BIPOLAR OCTAL D-TYPE FLIP-FLOP

BASED ON TYPE 54LS377

ESA/SCC Detail Specification No. 9203/035

DOCUMENTATION CHANGE NOTICE

FIGURE 3(a) - PIN ASSIGNMENT

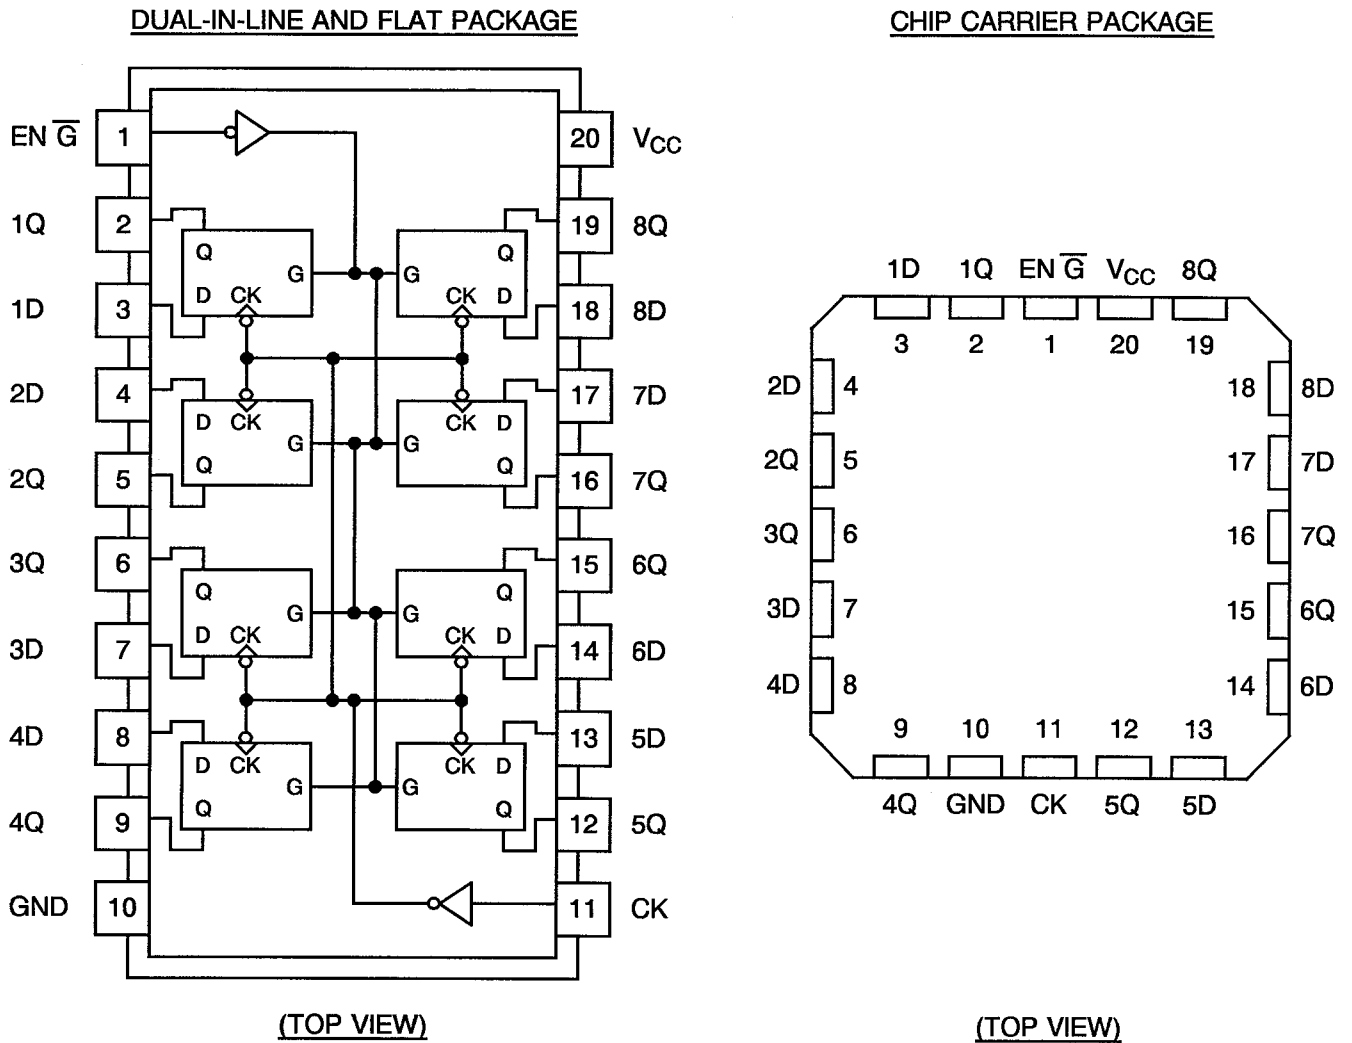
Figure 3(a)	: Figure for chip carrier package added	22881
			: Subtitles added above both drawings	22881
		Figure 3(b)	: Note amended	23519
		Para. 4.2.2	: PIND deviation deleted, "None" added	21048
		Para. 4.2.4	: Deviation deleted, "None" added	22919
		Para. 4.2.5	: Deviation deleted, "None" added	22919
		Para. 4.3.2	: Paragraph rewritten	23460/ 22920
		Para. 4.4.2	: Paragraph rewritten	23460/ 22920
		Para. 4.5.2	: Paragraph rewritten	23460/ 22920
		Para. 4.5.3	: Paragraph standardised	23519
		Para. 4.6.3	: "...and functional test sequence..." deleted	23519
		Para. 4.7.1	: "T _{amb} " added before "... +22 ± 3°C"	23519
		Paras. 4.7.2 & 4.7.3	: In title and paragraph, "burn-in" amended to read "power burn-in"	23519
		Figure 4(h)	: t _{PHL} changed to t _{PLH} (twice)	None
		Table 5	: No. 4, "GEN1" and "GEN2" added	23416
		Figure 5	: Drawing amended to include "GEN1" and "GEN2"	23416
		Para. 4.8	: Title amended	23519
